## Proposal for amendments to ECE/TRANS/WP.29/GRSP/2013/7

### Proposal for amendment of the draft gtr on pole side impact

The text reproduced below was prepared by the expert from Australia. Proposed modifications to the current text of the draft gtr on pole side impact (ECE/TRANS/WP.29/GRSP/2013/7) are marked in bold for new or strikethrough for deleted characters.

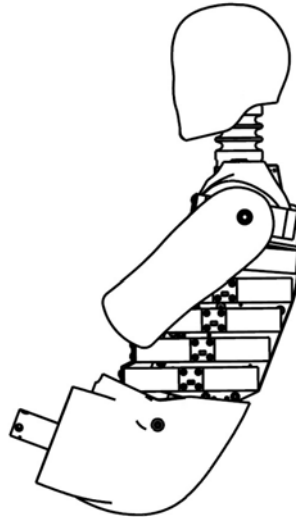
13. *Annex 2, paragraph 7.4.3. (new):* provides a more technically precise wording. See example images showing lower abdominal rib position relative to pelvis flesh below. The outer band of each lower abdominal rib can be more accurately described as positioned “in-behind the inner abdominal wall of the pelvis flesh” rather than “inside the pelvis flesh”.

"7.4.3. Where there is interference between the lower abdominal rib coupler and/or the outer band of each (i.e. left/right) lower abdominal rib assembly contacts the pelvis flesh, ensure a repeatable placement of the contacting surfaces of the lower abdominal rib coupler and by making sure the lower edge of the outer band of each lower abdominal rib, is inside are positioned in-behind the inner abdominal wall of the pelvis flesh and, not on top of it-the pelvis flesh."

Source: WorldSID drawing number W50-00000 ([standards.iso.org/iso/15830](https://standards.iso.org/iso/15830))

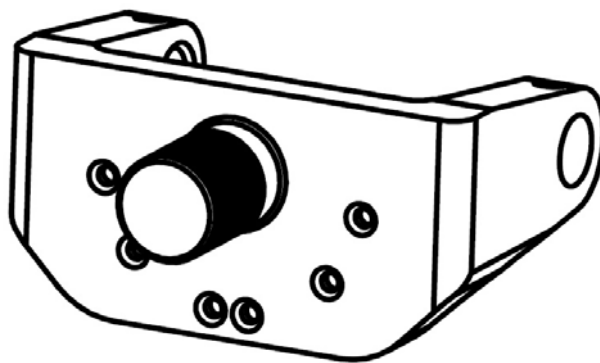
- 
7. *Annex 2, paragraph 2.6. (new) and paragraph 2.7.:* amendments proposed will provide more technically accurate definitions. The upper thorax rib of the WorldSID 50<sup>th</sup> dummy is oriented slightly differently to the middle thorax rib, lower thorax rib and abdominal ribs (see illustration below). The thorax tilt sensor angle reading about the sensor y-axis will indicate the angle of the middle thorax rib, lower thorax rib and abdominal ribs relative to a level surface or horizontal reference plane.

"2.3. "Design rib angle" means the nominal (theoretical) angle of the WorldSID 50th percentile adult male **middle thorax, lower thorax** and abdominal ribs relative to a level surface or horizontal reference plane, as defined by the manufacturer for the final adjustment position of the seat in which the dummy is to be installed. The design rib angle corresponds theoretically to the design torso angle minus 25°."

"2.6. "Dummy rib angle" means the angle of the test dummy **middle thorax, lower thorax** and abdominal ribs relative to a level surface or horizontal reference plane, as established by the thorax tilt sensor angle reading about the sensor y-axis. The dummy rib angle corresponds theoretically to the actual torso angle minus 25°."

Source: WorldSID drawing number W50-61113 sheet 1 ([standards.iso.org/iso/15830](https://standards.iso.org/iso/15830))

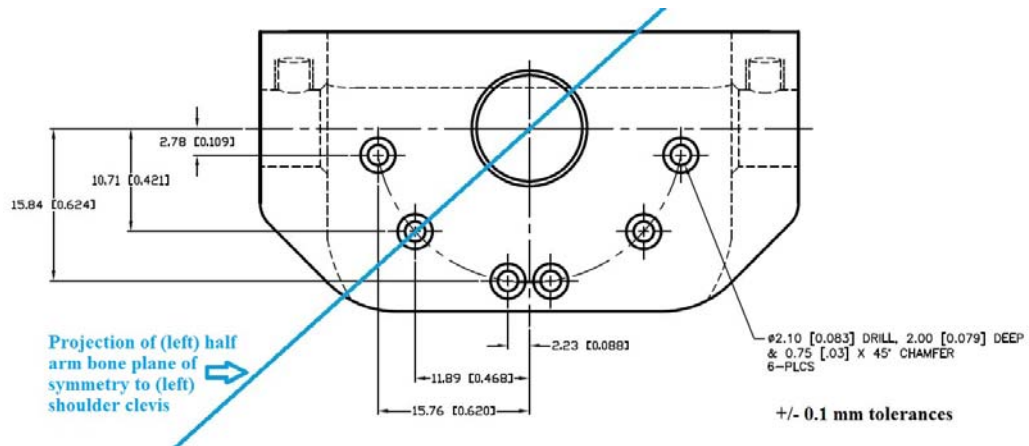
8. *Annex 2, paragraph 2.12. (new):* re-numbering of paragraph cross reference due to proposed deletion of "coronal plane" definition.
9. *Annex 2, paragraph 2.15. (new):* provides a "shoulder median plane" definition which is used to locate the detent position the dummy arms are placed at for the test. The shoulder clevis referred to in the definition of the shoulder median plane is shown below.

"2.15. "**Shoulder median plane**" means a plane dividing the left or right (as applicable) shoulder clevis into symmetrical anterior/posterior sections. The shoulder median plane is perpendicular to the centreline of the shoulder pivot shaft and parallel to the shoulder load cell y-axis (or an equivalently oriented axis of a shoulder load cell structural replacement)."
